Access Compliance Report

Public Rights-of-Way

Intersection ID: 47912	Main Street: MOUNTAIN_QUAIL_DR	Cross Street: MEARN_RD	Location: W
ADA ID: 2288E8DD986E	Ramp Type: PerpDiag	Initial Pass/Fail: Fail	Overall Compliance: No
Severity Score: 17.5			
Codes/Mitigation Info/Possible Solution		Field Measurements/Component Compliance

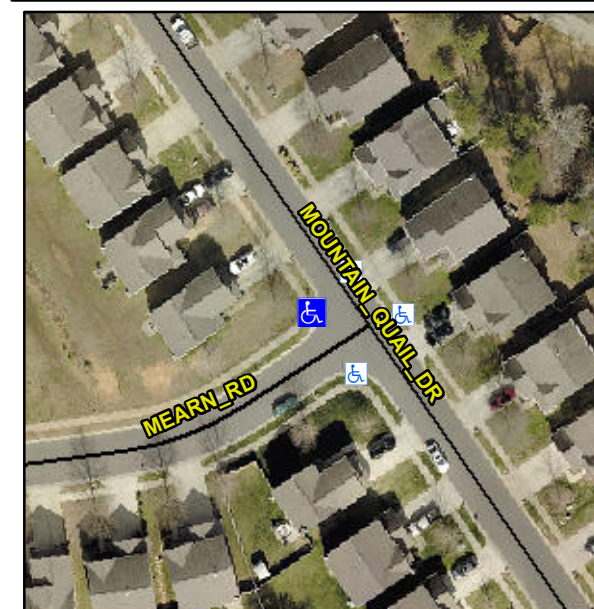
Not Found, R304.5.1

Compliance	Description	Data	Compliance	Description	Data
N/A	Ramp Length (in)	48.0	Yes	Ramp Slope (%)	5.3
No	Ramp Width (in)	33.5	Yes	Ramp XSlope (%)	1.2
N/A	Flare Type LT	N/A	N/A	Flare Type RT	N/A
N/A	Flare Slope LT (%)	N/A	N/A	Flare Slope RT (%)	N/A
N/A	Flare Traversable LT?	N/A	N/A	Flare Traversable RT?	N/A
N/A	Landing Length (in)	N/A	N/A	DWS Provided?	N/A
N/A	Landing Width (in)	N/A	N/A	DWS Contrast?	N/A
N/A	Landing Slope (%)	N/A	N/A	DWS Length (in)	N/A
N/A	Landing X Slope (%)	N/A	N/A	DWS Full Width?	N/A
N/A	Landing Curb? (Y/N)	N/A	N/A	DWS Offset (in)	N/A
N/A	Shared Landing?	N/A			
N/A	Gutter Ponding?	N/A	N/A	Gutter Slope (%)	N/A
N/A	Gutter Lip Ht (in)	N/A	N/A	Gutter X Slope (%)	N/A
N/A	Painted X Walk1?	No	N/A	Painted X Walk2?	No
	X Walk 1 Direction	To SE		X Walk 2 Direction	To E
N/A	X Walk 1 Width (in)	N/A	N/A	X Walk 2 Width (in)	N/A
	X Walk 1 Slope (%)	0.3		X Walk 2 Slope (%)	10.1
	X Walk 1 X Slope (%)	2.3		X Walk 2 X Slope (%)	0.3

Remove & Replace Curb Ramp With Two New Directional Ramps or Equivalent.
